D-014

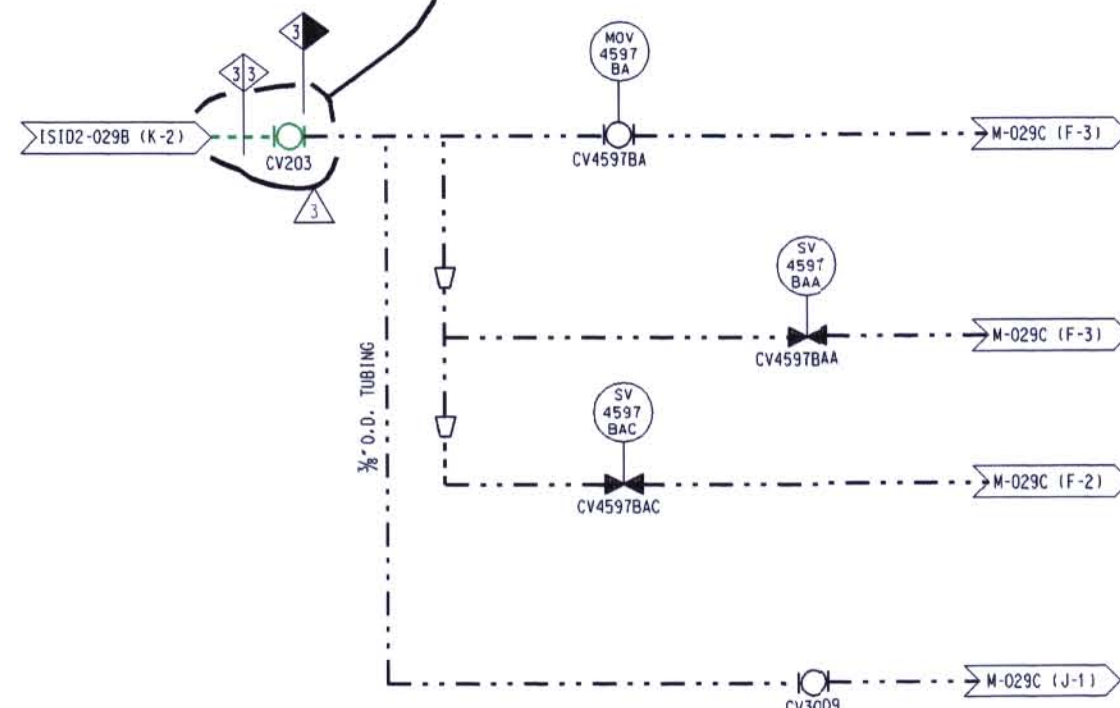
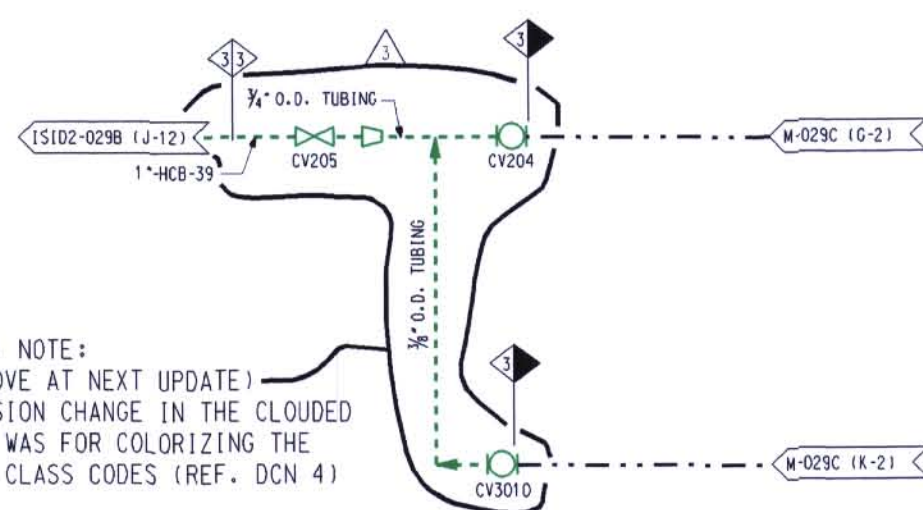
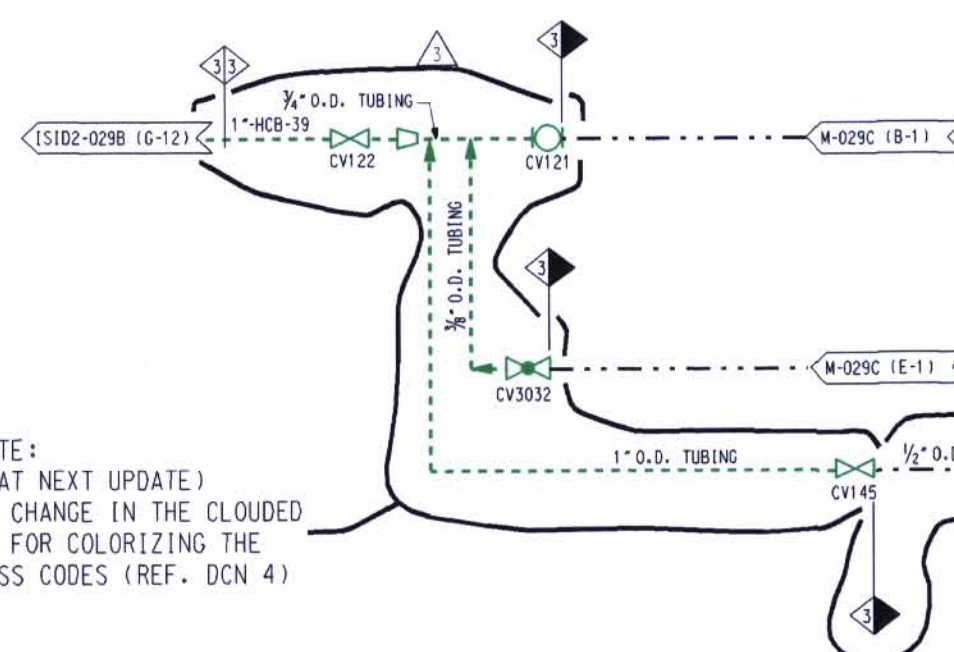
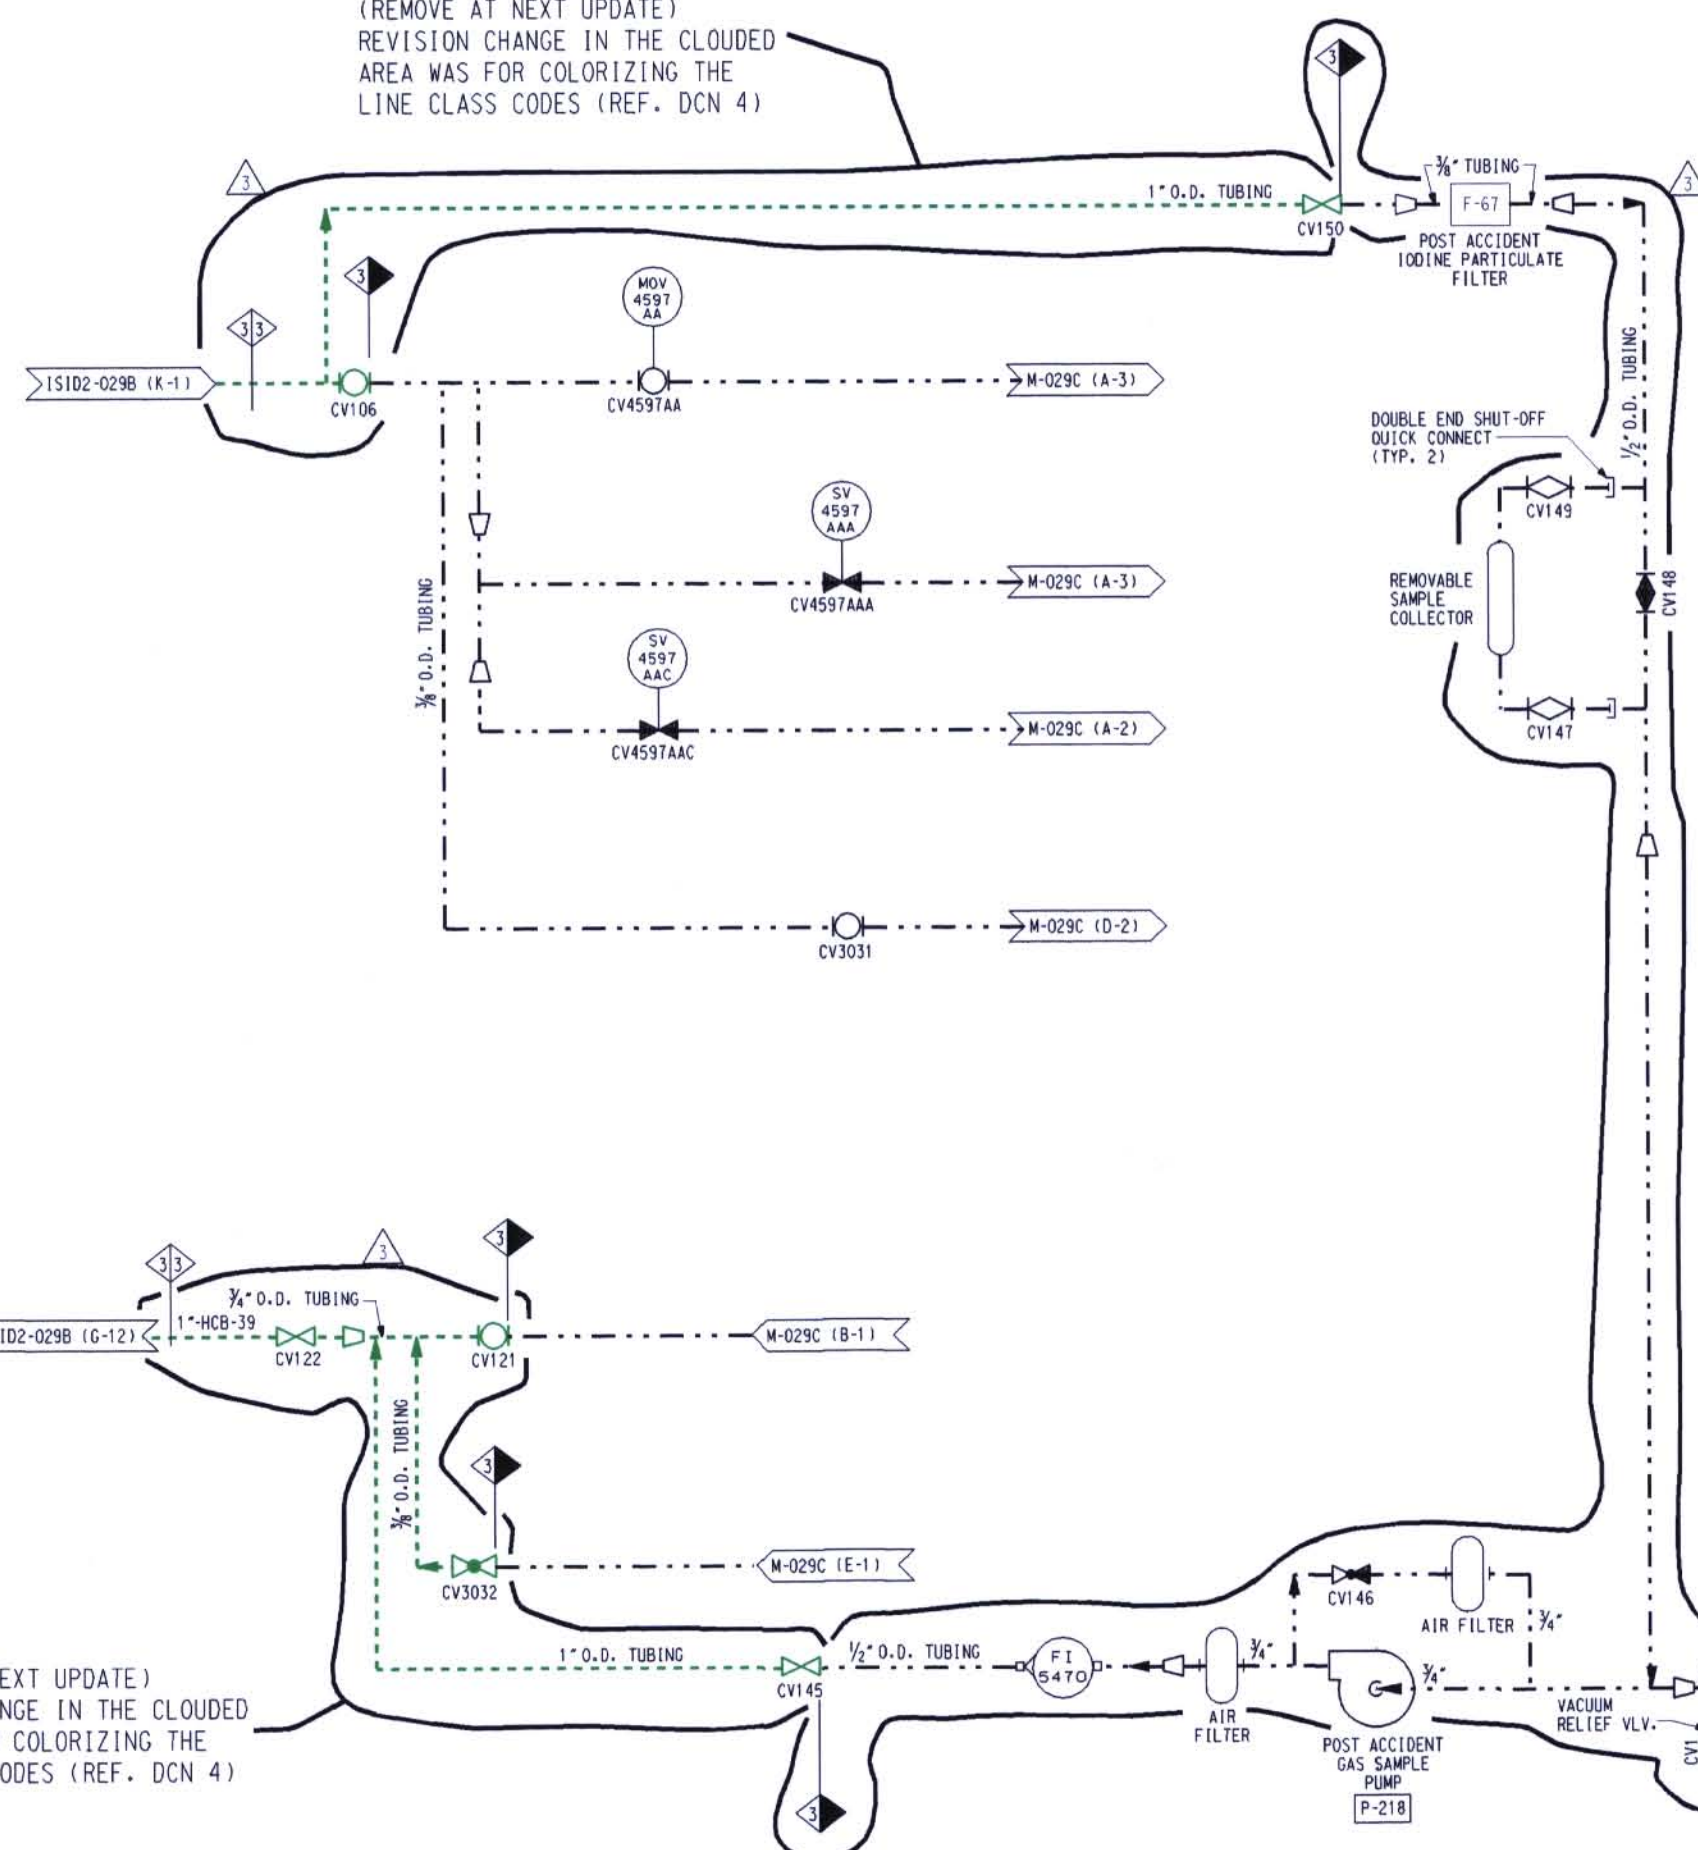
INFO. NOTE:  
(REMOVE AT NEXT UPDATE)  
REVISION CHANGE IN THE CLOUDED  
AREA WAS FOR COLORIZING THE  
LINE CLASS CODES (REF. DCN 4)

INFO. NOTE:  
(REMOVE AT NEXT UPDATE)  
(REVISION CHANGE IN THE CLOUDED  
AREA WAS FOR COLORIZING THE  
LINE CLASS CODES (REF. DCN 4)

INFO. NOTE:  
(REMOVE AT NEXT UPDATE)  
REVISION CHANGE IN THE CLOUDED  
AREA WAS FOR COLORIZING THE  
LINE CLASS CODES (REF. DCN 4)

INFO. NOTE:  
(REMOVE AT NEXT UPDATE)  
REVISION CHANGE IN THE CLOUDED  
AREA WAS FOR COLORIZING THE  
LINE CLASS CODES (REF. DCN 4)
